## DEVIATION REQUEST AND DECISION FORM

Project Name :	Grandview Reserve
Schedule No.(s) :	
Legal Description :	<p>A TRACT OF LAND BEING PORTIONS OF THE SOUTH HALF OF SECTION 21, SOUTH HALF OF SECTION 22, NORTH HALF OF SECTION 28 AND SECTION 27, TOWNSHIP 12 SOUTH, RANGE 64 WEST OF THE SIXTH PRINCIPAL MERIDIAN, EL PASO COUNTY, COLORADO, BEING DESCRIBED AS FOLLOWS:</p> <p>BASIS OF BEARINGS: THE EAST LINE OF SECTION 21, BEING MONUMENTED AT THE SOUTHEAST CORNER BY A 3-1/4" ALUMINUM SURVEYOR'S CAP STAMPED "PS INC PLS 30087 1996", BEING APPROPRIATELY MARKED, AND BEING MONUMENTED AT THE NORTHEAST CORNER BY A 3-1/4" ALUMINUM SURVEYOR'S CAP STAMPED "PS INC PLS 30087 1996", BEING APPROPRIATELY MARKED, BEING ASSUMED TO BEAR NORTH 00 DEGREES 52 MINUTES 26 SECONDS WEST, A DISTANCE OF 5290.17 FEET.</p> <p>COMMENCING AT THE SOUTHEAST CORNER OF SAID SECTION 21; THENCE NORTH 00 DEGREES 52 MINUTES 26 SECONDS WEST ON THE EAST LINE OF SAID SECTION, A DISTANCE OF 2645.09 FEET TO THE NORTHEAST CORNER OF THE SOUTHEAST QUARTER OF SAID SECTION 21, SAID POINT BEING THE POINT OF BEGINNING; THENCE NORTH 89 DEGREES 41 MINUTES 03 SECONDS EAST ON THE NORTH LINE OF THE SOUTH HALF OF SAID SECTION 22, A DISTANCE OF

Figure 1- Proposed Cross Section for MST

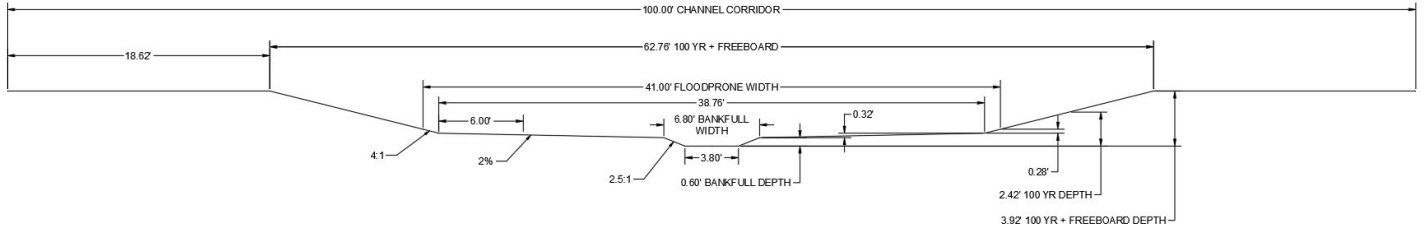
Denial of the deviation is recommended at this time due to insufficient justification. If this is pursued, additional comparison to other jurisdictions with up-to-date engineering practices needs to be provided, as well as the additional information requested regarding what the design would be to meet criteria.

Provide the required cross-section based on criteria for comparison.
